U. S. NUCLEAR REGULATORY COMMISSION  
OFFICE OF INSPECTION AND ENFORCEMENT

Report No. 50-206/79-16  
Docket No. 50-206 License No. DP-13 Safeguards Group \_\_\_\_\_  
Licensee: Southern California Edison Company  
2244 Walnut Grove Avenue  
Rosemead, California 91770  
Facility Name San Onofre Unit 1  
Inspection at San Onofre and Rosemead, California  
Inspection conducted: November 1-2 and 26, 1979  
Inspectors: L. F. Miller, Reactor Inspector December 19, 1979  
Date Signed  
A. Johnson, Reactor Inspector January 4, 1980  
Date Signed  
B. Pate, Resident Reactor Inspector January 4, 1980  
Date Signed  
B. H. Faulkenberry, Chief, Reactor Projects  
Section #2  
Approved By: B. H. Faulkenberry January 4, 1980  
Date Signed  
B. H. Faulkenberry, Chief, Reactor Projects  
Section #2, Reactor Operations and Nuclear Support Branch

Summary:

Inspection on November 1-2, 1979 and November 26, 1979 (Report No. 50-206/79-16)  
Areas Inspected: Routine, announced inspection of scope and methods of field inspection for IE Bulletin 79-14; routine, unannounced inspection of repair of shorted electrical buswork from the November 7, 1979 reportable occurrence; discussions of this event, of th

SIMPLIFIED  
ONE-LINE  
FOR SWYD  
CUT-OVER

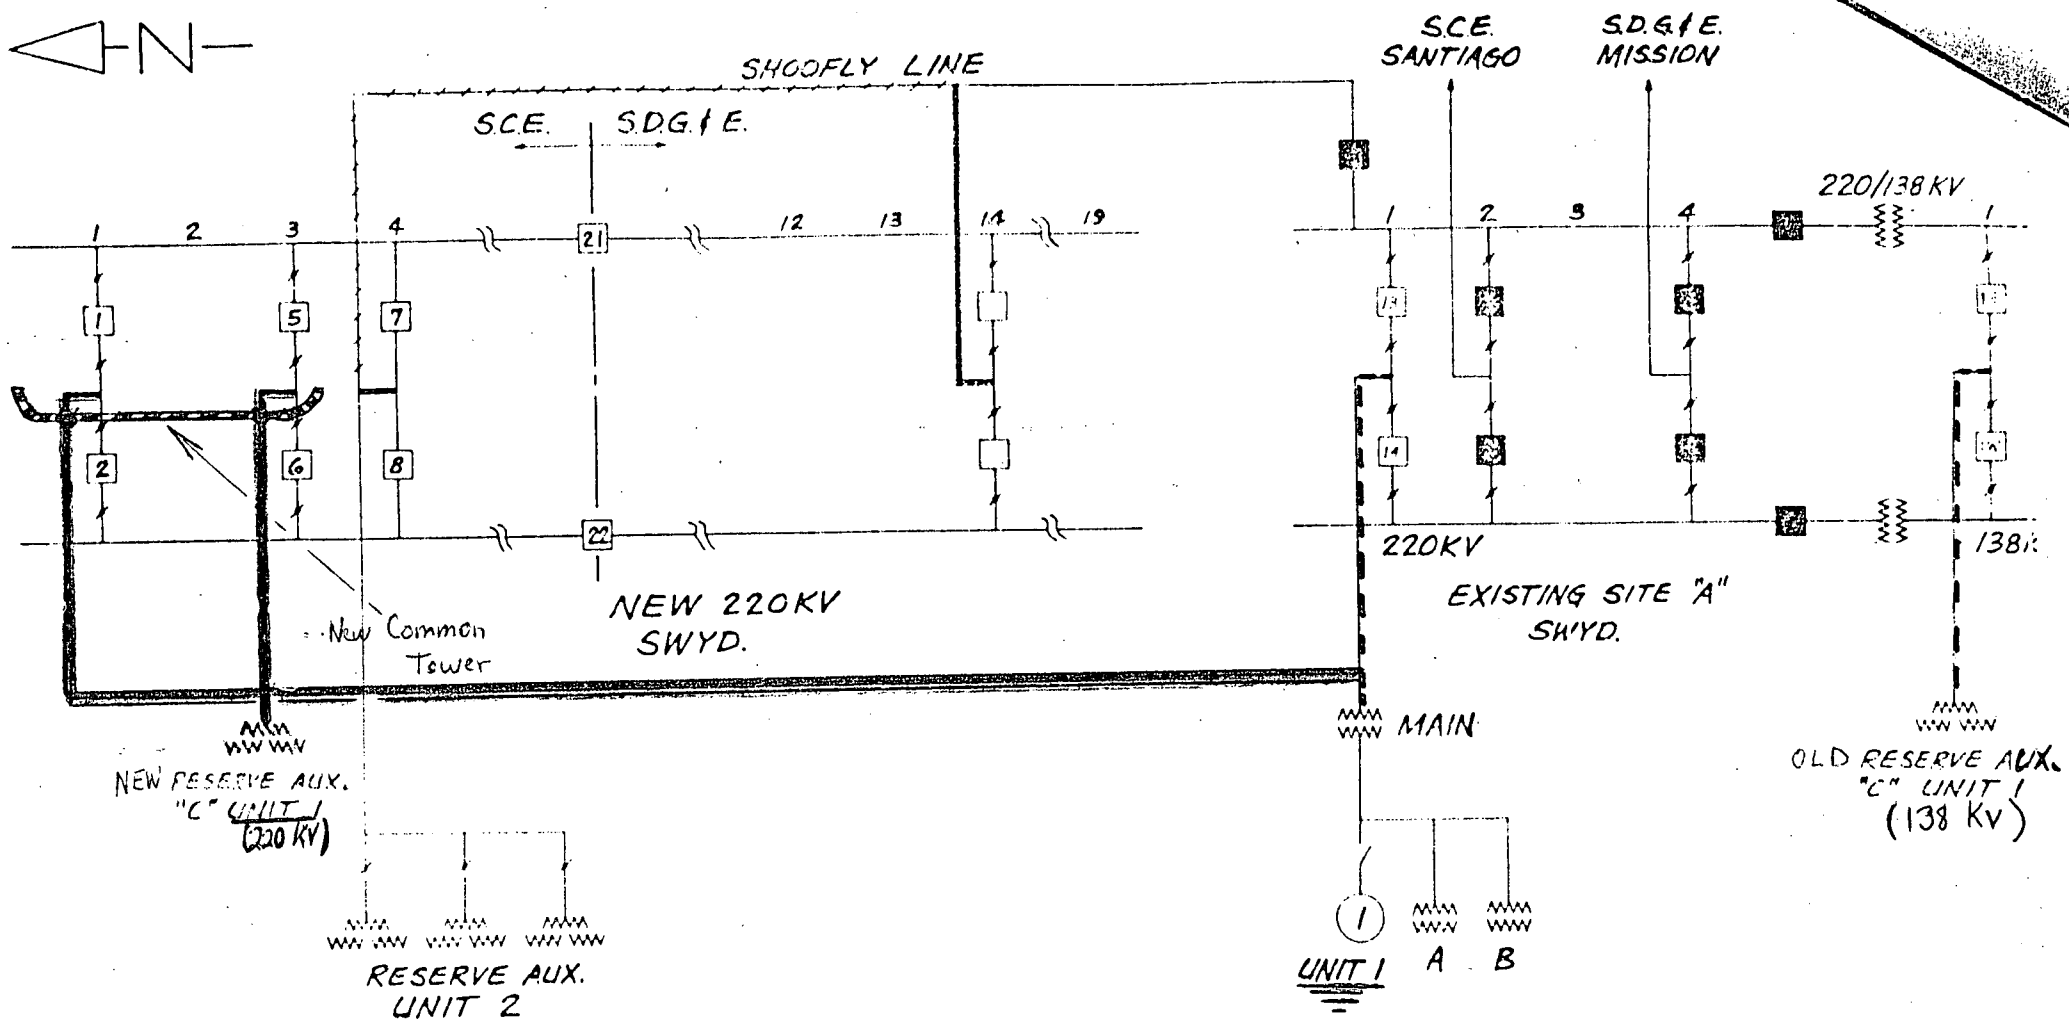
An exit interview was conducted on November 26, 1979 to discuss the licensee's plan to switch over offsite power to the new station 220 KV switchyard during the next refueling outage. The design change, 79-20, would replace the existing offsite transmission lines from the onsite electrical busses to the existing 220 KV/138 KV Switchyard with new transmission lines, towers, transformers, and a 220 KV-only Switchyard (Figure 1). This change is part of the licensee's plan to integrate San Onofre Units 1, 2 and 3 offsite power distribution into a common site 220 KV Switchyard (Units 2 and 3 are under construction). As planned, the new transmission lines from the Unit 1 onsite power busses to the new switchyard would share one tower of their respective transmission paths to the site switchyard. This would be a significant departure from the present offsite power network described in the FSAR (p. 3-29): "The 220 KV and 138 KV transmission lines between the Switchyards and the station are physically separated (emphasis added) to keep a postulated tower failure on one circuit from affecting the other circuit." After the change, the only two transmission paths from the site to the new switchyard would no longer be physically independent, because they would now pass onto a common tower located inside the perimeter of the switchyard. Failure of the new common tower could simultaneously fault both lines. This possibility for one tower failure faulting both lines does not exist with the present network because there are no common towers for the two independent lines to the existing switchyard. Therefore, the probability of loss of all offsite power would be increased by this change. Since loss of all offsite power is an accident or malfunction of equipment important to safety evaluated in the Safety Analysis Report (Section 9), this design change would appear to be an unreviewed safety question, as defined by 10 CFR 50.59(a)(2).

The licensee representative stated that it was his understanding they had received approval from the Office of Nuclear Reactor Regulation (NRR) to proceed with this change. The inspectors noted that they were aware of the meeting which had been held between the licensee and NRR, and NRR's acceptance of the proposed design change. The inspectors informed the licensee representative that since this change appears to be an unreviewed safety question, the licensee will be in noncompliance if the change is made prior to receiving formal review and approval from NRR in accordance with 10CFR 50.59 requirements. The licensee representative acknowledged the inspector's statement.

1. CONNECT SHOOFLY TO POSITION 14. (OCT. '79)
2. CONNECT UNIT 1 MAIN AND RES. AUX. TRANSFORMERS TO NEW SWYD. (MARCH '80)
3. KEEP SITE "A" ENERGIZED UNTIL NOV. 1980, i.e. THE CONTROLS OF SCE. PCB'S SHOWN AS HAVE TO BE OPERABLE.
